City of Portland, Maine – Building or Use Permit Application 389 Congress Street, 04101, Tel: (207) 874-8703, FAX: 874-8716

BUILDING PERMIT REPORT

DATE: 25 MAY 99 ADDRESS: 47 Hersey St. CBL: 129-F-022
 REASON FOR PERMIT: Replace existing garage & slab
 BUILDING OWNER: Constance Tidd
 PERMIT APPLICANT: _____ / Contractor Owner
 USE GROUP R-3 "U" BOCA 1996 CONSTRUCTION TYPE 5-B

TIDD GARAGE
47 Hervey St.

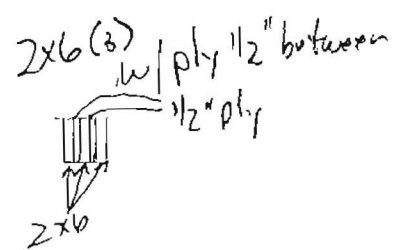
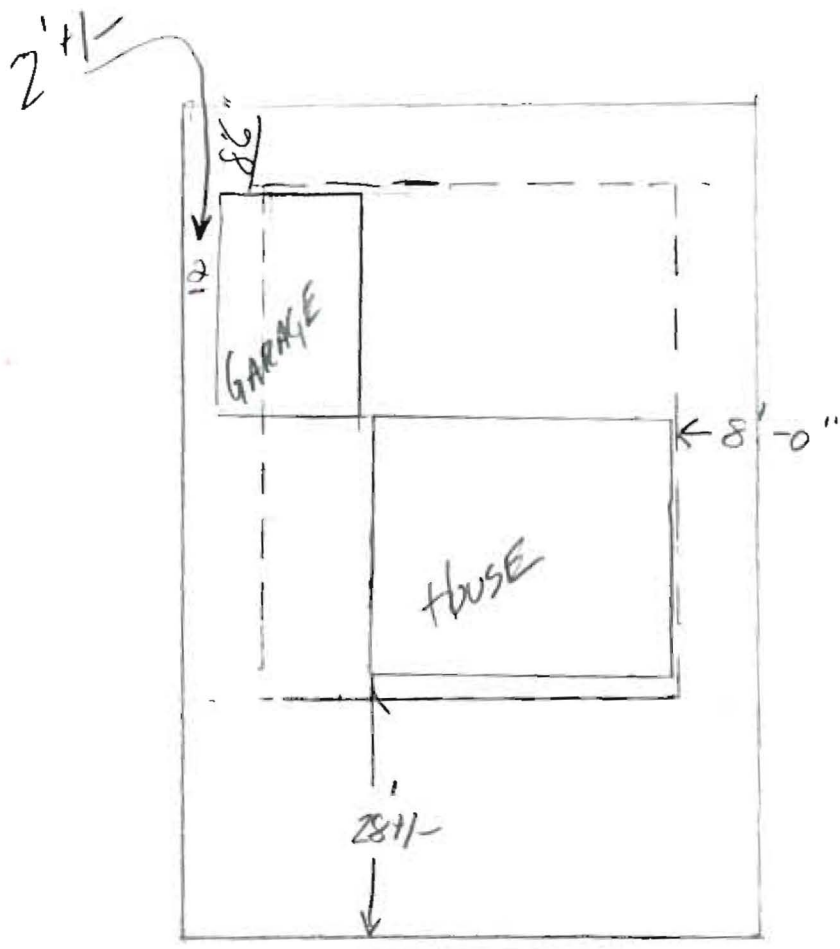
- 6-2-99 1 Block Header over Garage Door.
- 2 Turn Headers over Door (Side) + Windows.
- 3 Install Ridge Pole Entire Length
- 4 Install collar ties on Rafters.

Bill Tocher will be correcting the violation on the Garage
I met with him at the site and we went over all the violations
he will call when completed the stop order will be lifted.
after corrections are completed. (TR)

PLOT PLAN 1" = 20'-0"

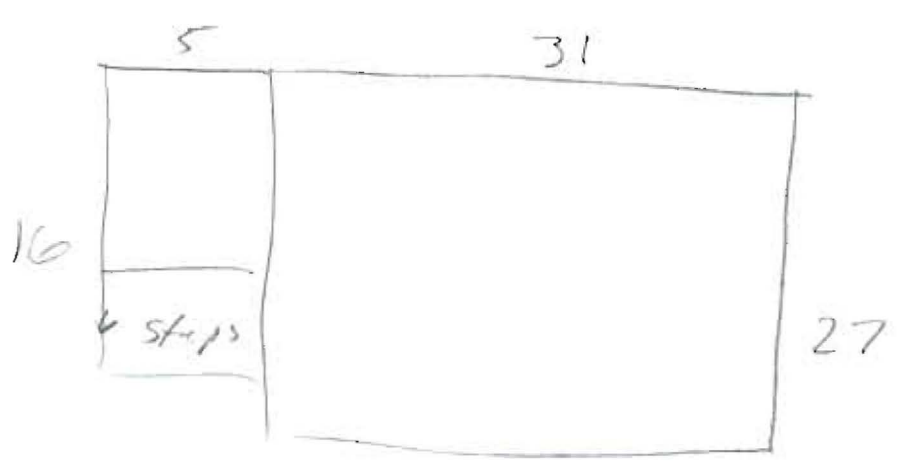
→ Rear Yard - 25' req - 8' 6" shown

→ Side Yard - 8' req - 2' shown

I am in receipt of your building permit to tear down an old garage and then to replace it with a new slab. It is my understanding that the garage has already been torn down. Your garage was legally nonconforming as to setbacks. When you tore down the garage, you lost your nonconforming rights (often called "grandfathered rights"). Your replacement garage will now be required to meet today's setback requirements within the Zoning Ordinance. Your structure is in the R-3 Residential Zone which requires a 25' rear setback and an eight foot side setback. The plot plan submitted shows an 8'6" rear setback and a 2' side setback.

I am denying your permit since you cannot meet the required setbacks in the R-3 Zone (Section 14-90(4)b. & c.). You have the right to appeal within 30 days of the date of this letter. I have attached copies of information that you will need in order to apply for an appeal. This is a Practical Difficulty Variance. It is not an easy variance to get. The Board of Appeals interprets the criteria very strictly. Please gear your arguments toward the criteria that the Board is required to consider.

11. Other requirements of condition Recent changes in the zoning ordinance allow me to now approve this permit application. You have until September 9, 1999 (1 year from tear down) to replace this garage on the same footprint, and keeping the same garage use.
Marge Schmuckal Marge Schmuckal, Zoning Administrator

OK per revised provisions in Non-conformity section which gives 1 yr to rebuild on the same footprint and same use - 3/24/99
